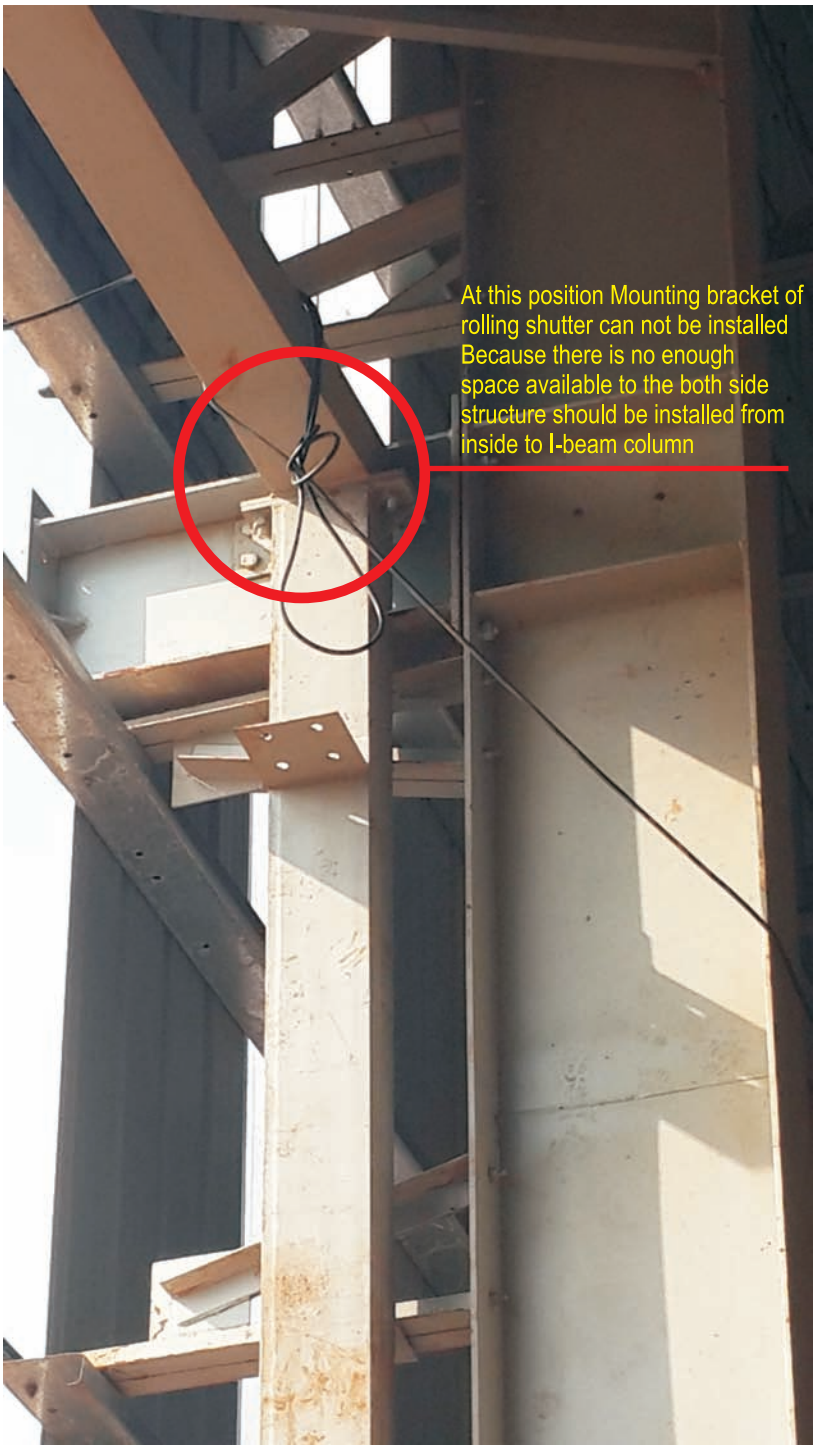
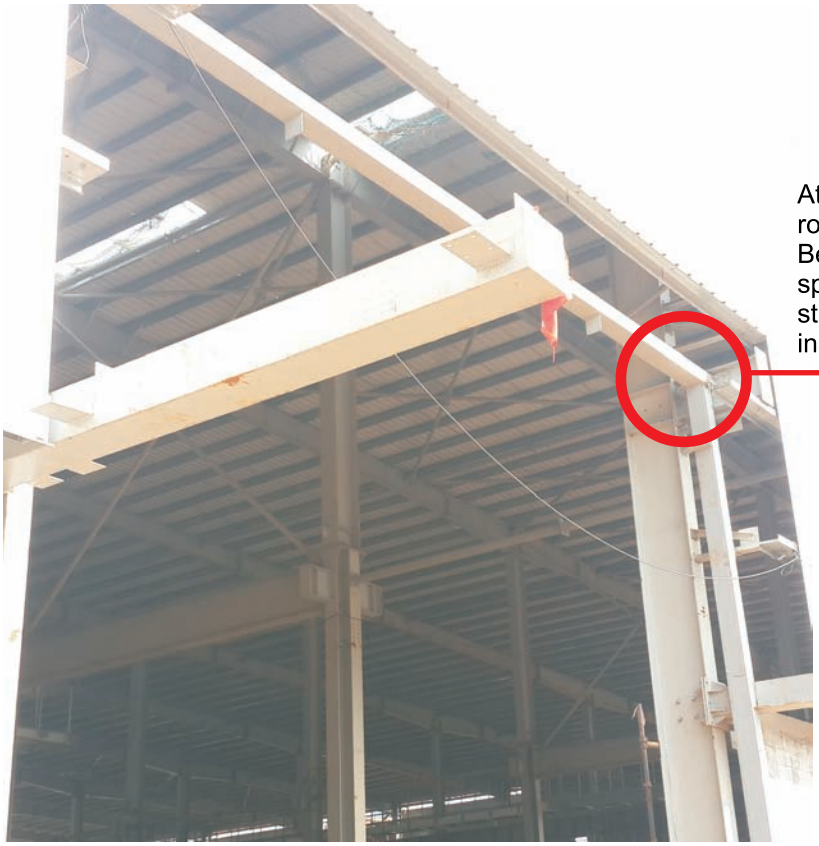
At this position Mounting bracket of rolling shutter can not be installed Because there is no enough space available to the both side. Structure should be installed from inside to I-beam column

At this position Mounting bracket of
rolling shutter can not be installed
Because there is no enough
space available to the both side
structure should be installed from
inside to I-beam column

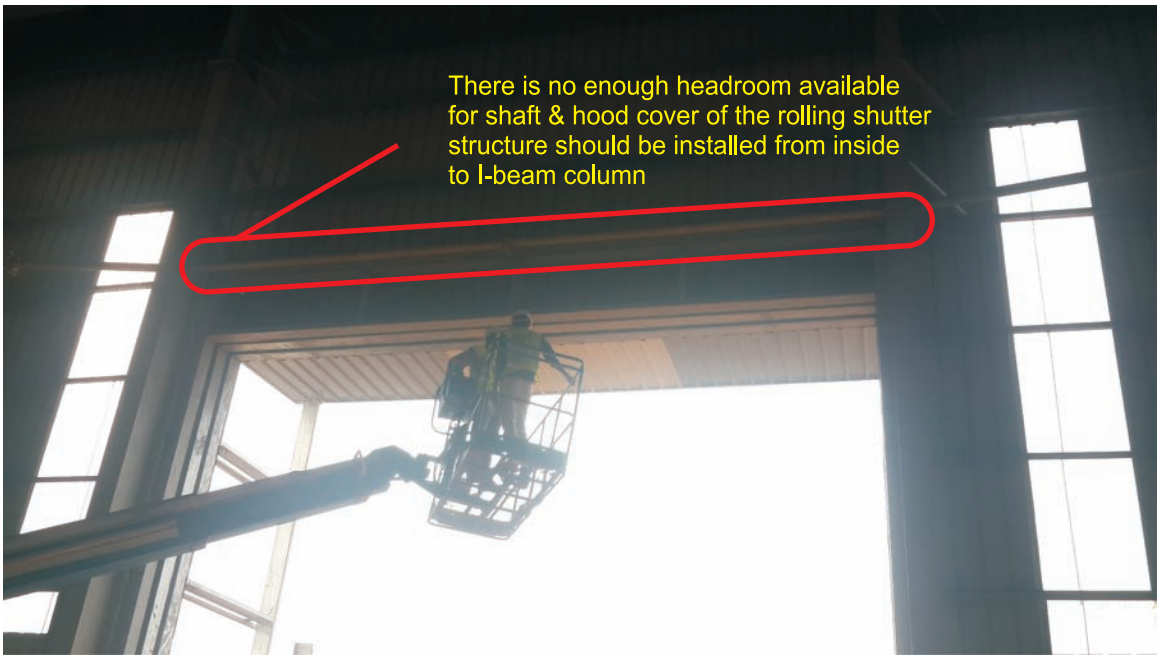
Structure for rolling shutter
should be installed from inside
to I-beam column

At this position MS bracket of rolling shutter can not be installed Because there is no enough space available to the both side structure should be installed from inside to I-beam column

No space available for Mounting Bracket
of rolling shutter structure should be installed
from inside to I-beam column

No space available for Mounting Bracket
of rolling shutter structure should be
installed from inside to I-beam column

There is no enough headroom available
for shaft & hood cover of the rolling shutter
structure should be installed from inside
to I-beam column
